LIMERICK GENERATING STATION

Docket No. 50-353  
License No. NPF-85

PROPOSED TECHNICAL SPECIFICATIONS CHANGES

List of Attached Change Pages

Figure 3.3.6-1

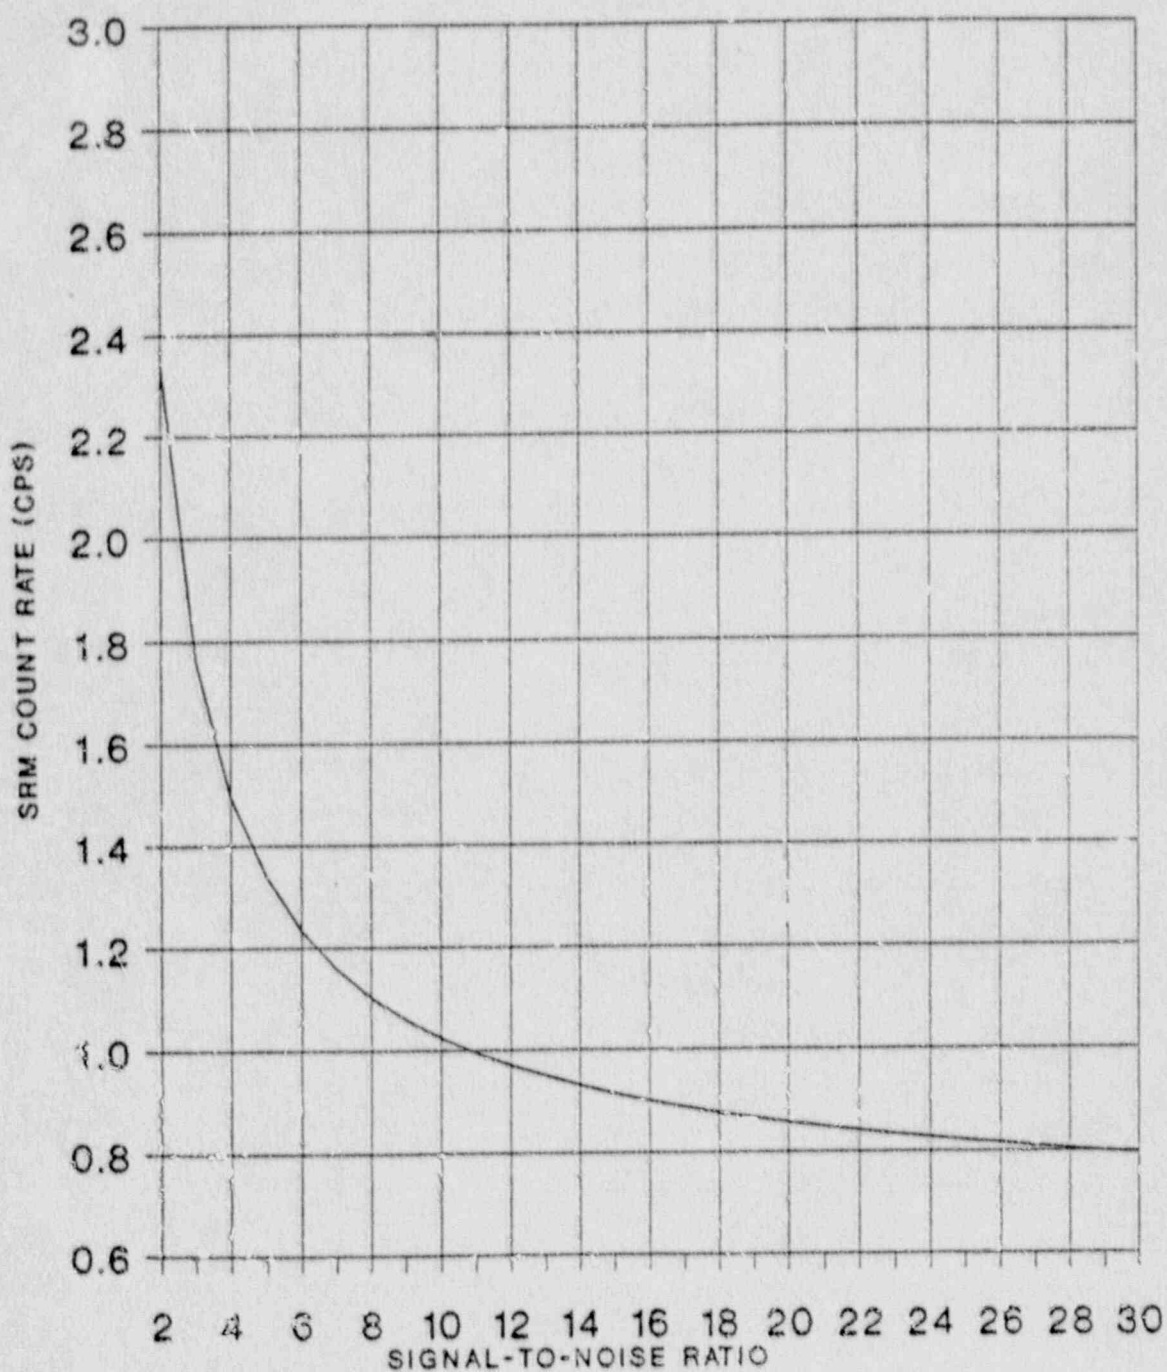
\*\* May be reduced, provided the source range monitor has an observed count rate and signal-to-noise ratio on or above the curve shown in Figure 3.3.6-1.

\*\*\* May be reduced, provided the source range monitor has an observed count rate and signal-to-noise ratio on or above the curve shown in Figure 3.3.6-1.

\*May be reduced, provided the source range monitor has an observed count rate and signal-to-noise ratio on or above the curve shown in Figure 3.3.6-1. These channels are not required when sixteen or fewer fuel assemblies, adjacent to the SRMs, are in the core.
